Subdivision Regulation Amendments

November 14, 2024

Common Topics of Comments Received

FIGURE 5.1

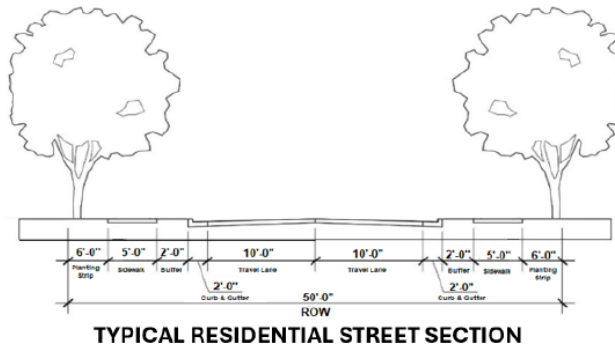
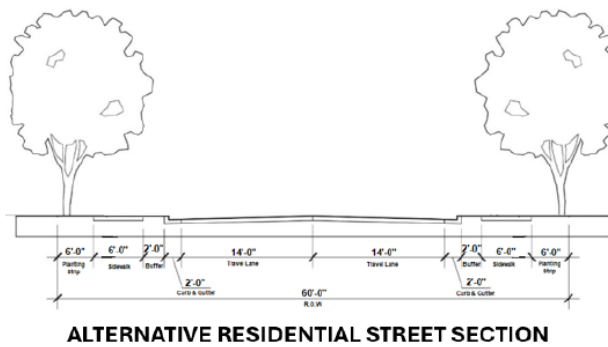
Provide utility corridors and consider allowing some utilities to be below the street and/or sidewalks. Add clarification for when the Alternative Street Section is to be used.

Agree. Will revise to allow street trees outside of the ROW but no further than 5 feet from ROW line. Alternative Street Section will be clarified to be required on streets where lots are between 60 feet and 80 feet in width.

Usable Open Space Requirement Flow Chart

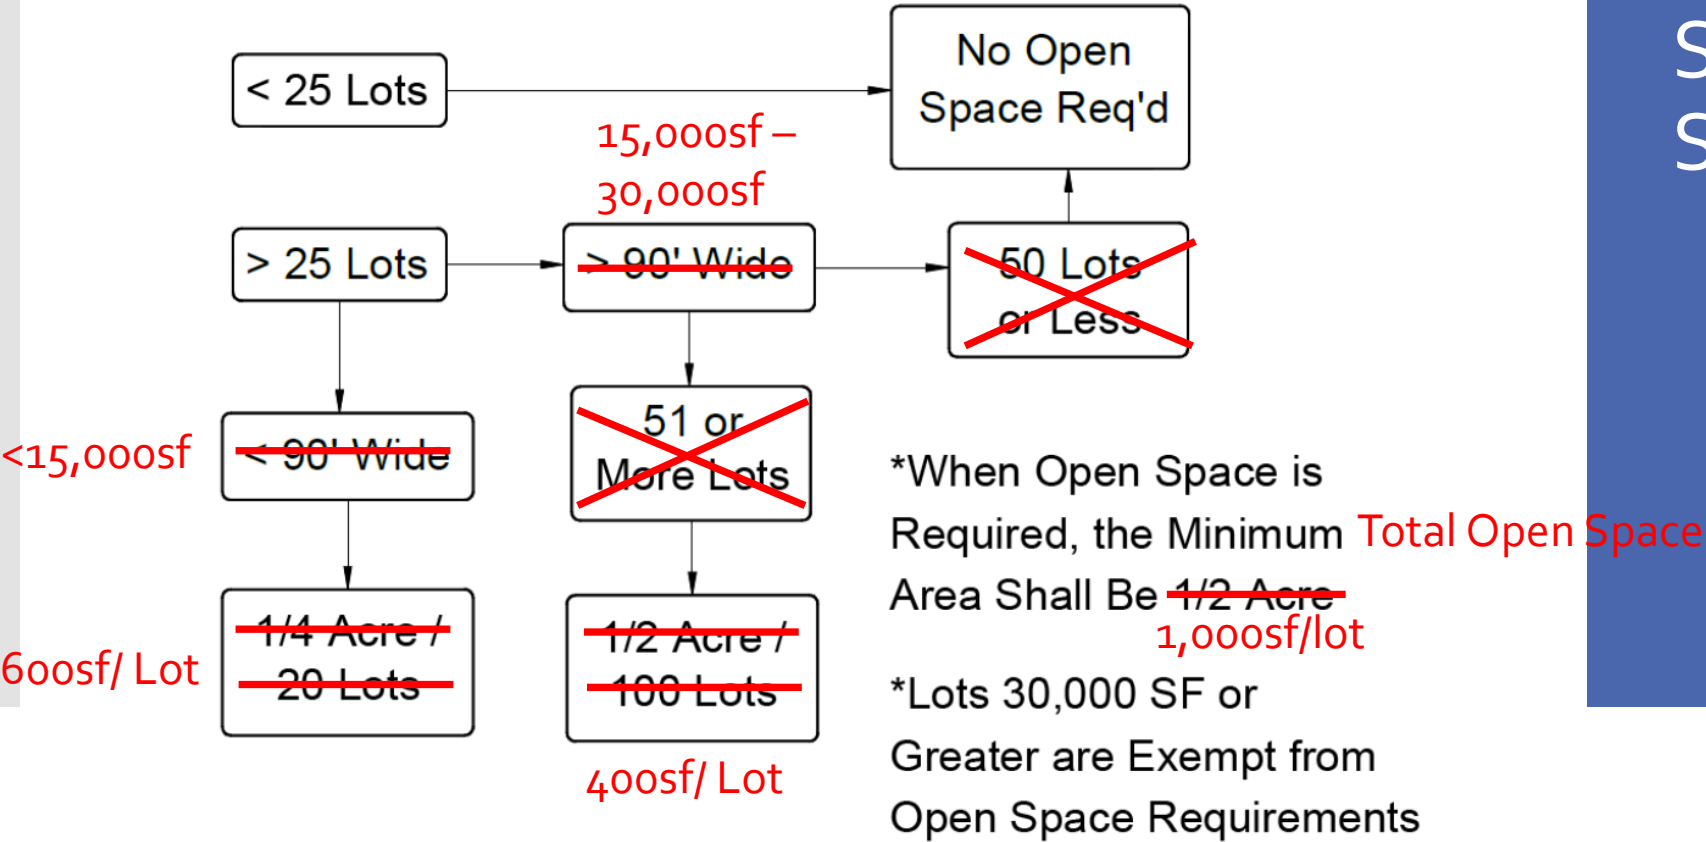
I do believe that Open Space is needed in developments once they have a certain number of lots, and especially when the lots are smaller with not much space in the yards. I have found that they encourage more density and smaller lots, in order to make up for the cost of land lost. We need a way to provide Open Space and encourage larger lots. My proposal is to base the Open Space on the number of units, as opposed to a flat percentage.

This is a common approach that would provide a mechanism to tie usable open space requirements to the context of the density being proposed. Would be better to categorize the lot sizes by square footage rather than width as area of open space is what is important so all measures should be by area rather than width. Proposed changes:

MINIMUM STANDARDS FOR TYPICAL RESIDENTIAL GRADING CONTROL PLAN

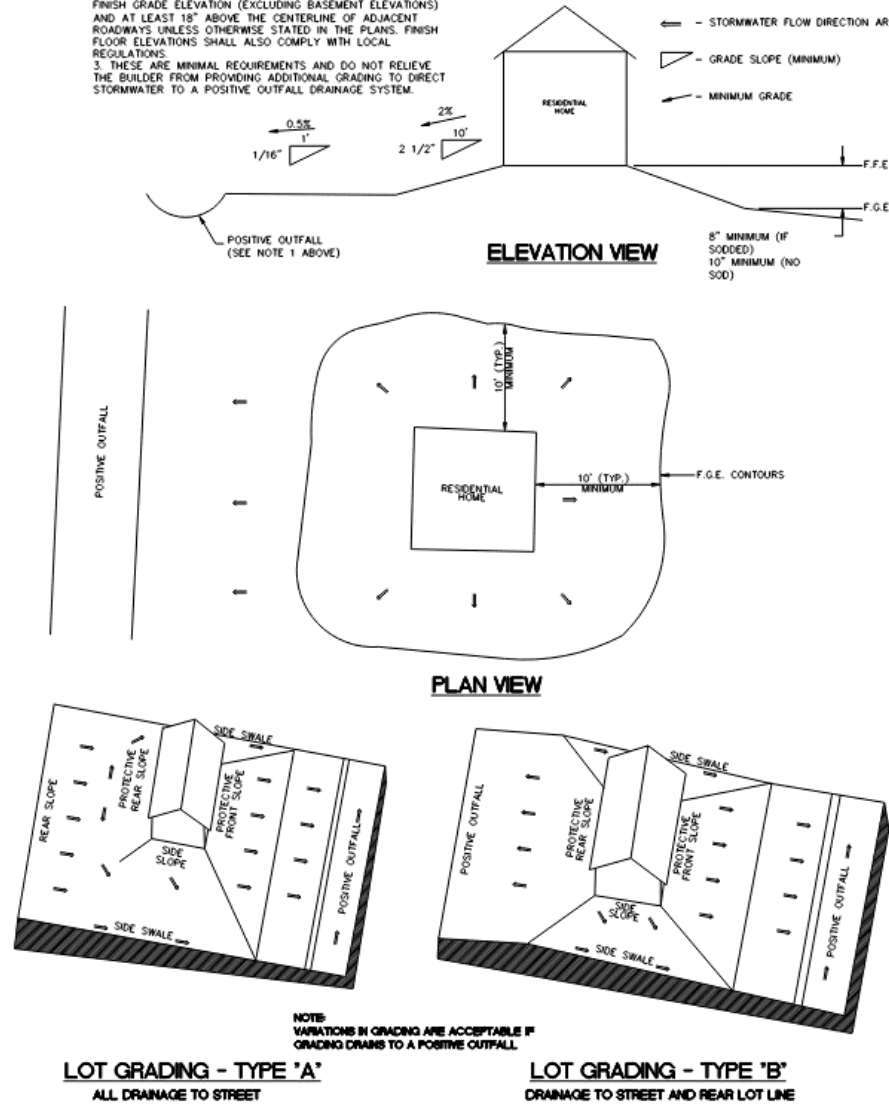
Comment Received 5.12.5(i): If the lot grading plan is a part of the approved construction plans County staff can require the lots be built exactly to those plans. Will the homebuilder be able to use another engineering firm to produce lot grading plants? Due to this, if a lot grading plan is required in construction plans, it should include proposed minimum FFEs, direction of stormwater flow and lot grading detail only. This gives the contractor and homebuilder enough information to grade the lots to match the engineer's intent for stormwater management. The detail could look something like this graphic.

Resolution: This is what we would expect for lot grading plan. Enough information that the future homebuilder (and their engineer) could grade the lot to work with the intent of the engineer of record of the development. We will add a graphic similar to this to clearly describe that this is what is required.

5.2.5(b) – Sanitary Sewer System

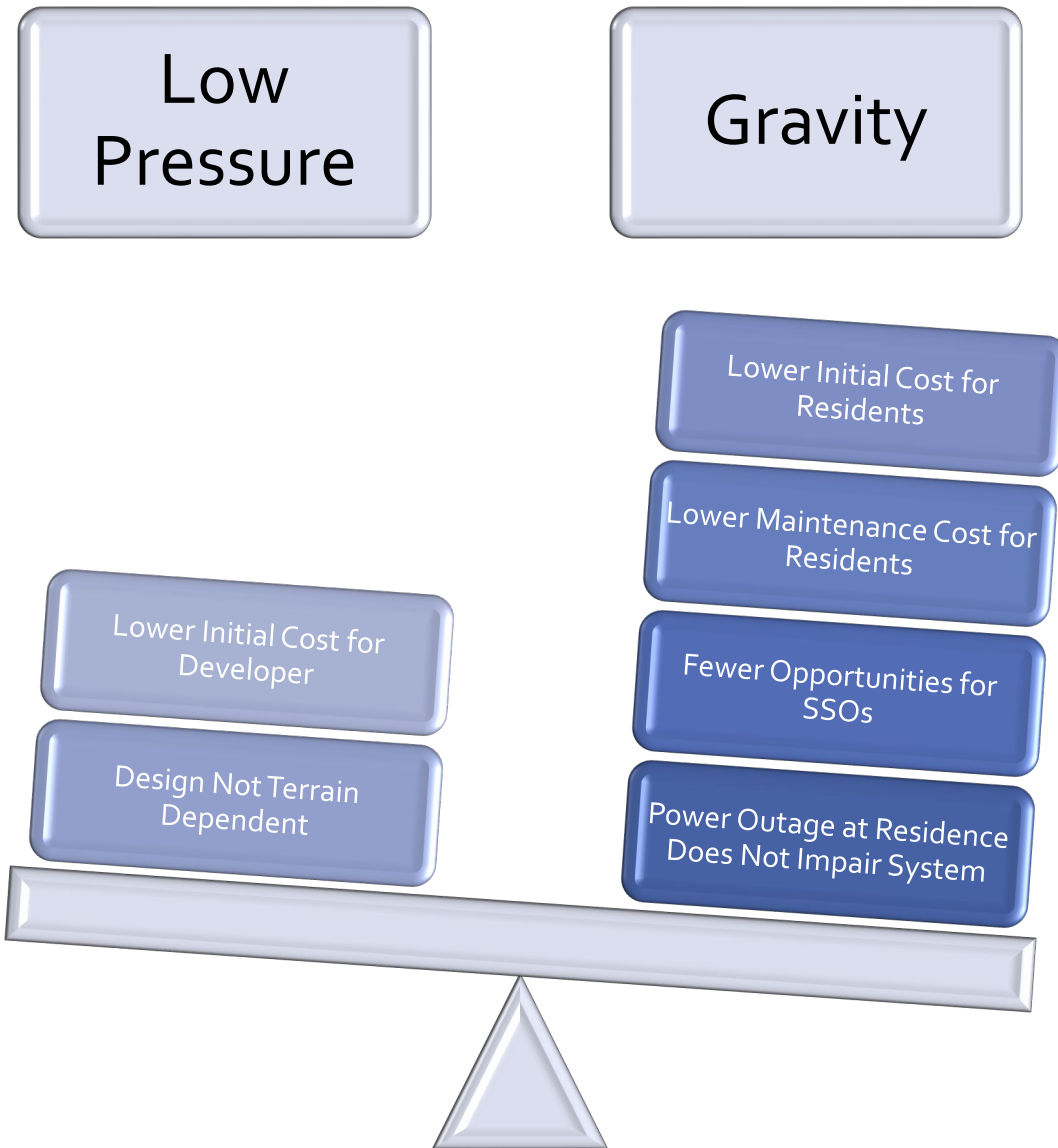
Comment Received: The proposed amendments to the subdivision regulations purport to limit the use of low-pressure sewer collection systems and the use of grinder pumps, which is a viable and proven system for the collection and transmission of wastewater for treatment along with gravity systems. In addition, in many areas that are subject to high levels of rain, wetland areas, and areas subject to flooding and/or significant surface drainage, gravity systems, which are open systems which utilize manholes and other components which are not completely enclosed, allow the inundation of stormwater into the wastewater collection system resulting in significant increases of water in the system, which can result in sewer overflows. The design of the system should be left to the utility provider (and the engineer of record) which will be ultimately responsible for its construction, operation, and maintenance in accordance with ADEM requirements.
